Amendments to the Drawings

Serial No.: 10/617,466 Amendment Dated 12 July 2005 Reply to Office Action of 06 May 2005 Annotated Sheet Showing Changes

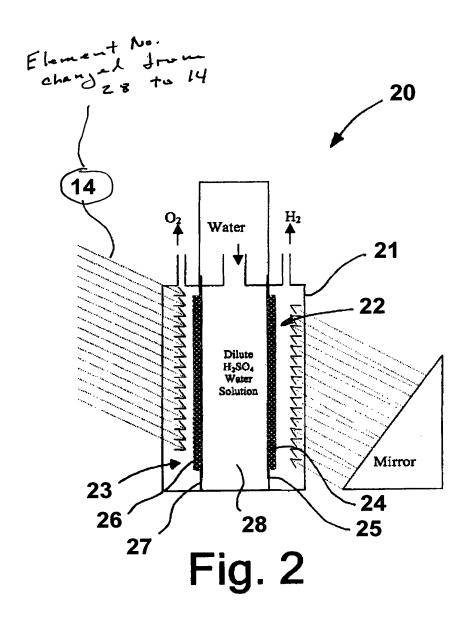
replace the original sheets of Figs. 1, 2 and 3. In Fig. 1, the label "Prior Art" has been

Fig. 1 has been objected to for failing to provide a legend to indicate that it shows only that which is old subject matter. In response, Applicant has added the label "Prior Art" to Fig. 1.

Fig. 3

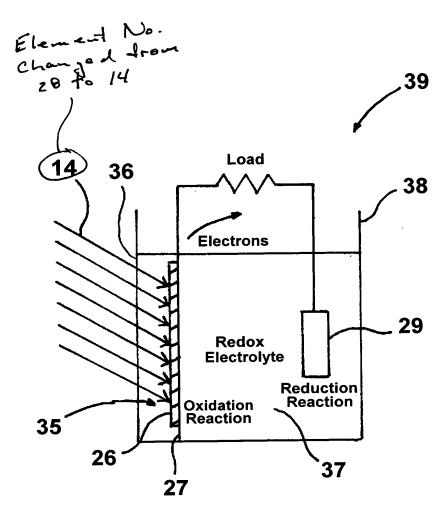
added; in Figs. 2 and 3, the reference character 28, which previously designated

sunlight, has been changed to reference character 14.

The drawings have been objected to as failing to comply with 37 CFR 1.84(p)(4) because the reference character "28" has been used to designate two elements, sunlight and electrolyte, in Figs. 2 and 3. In response to this objection, Applicant has amended the drawings to utilize reference character "14" to designate sunlight, which is consistent with the designation of sunlight shown in Fig. 1. To the
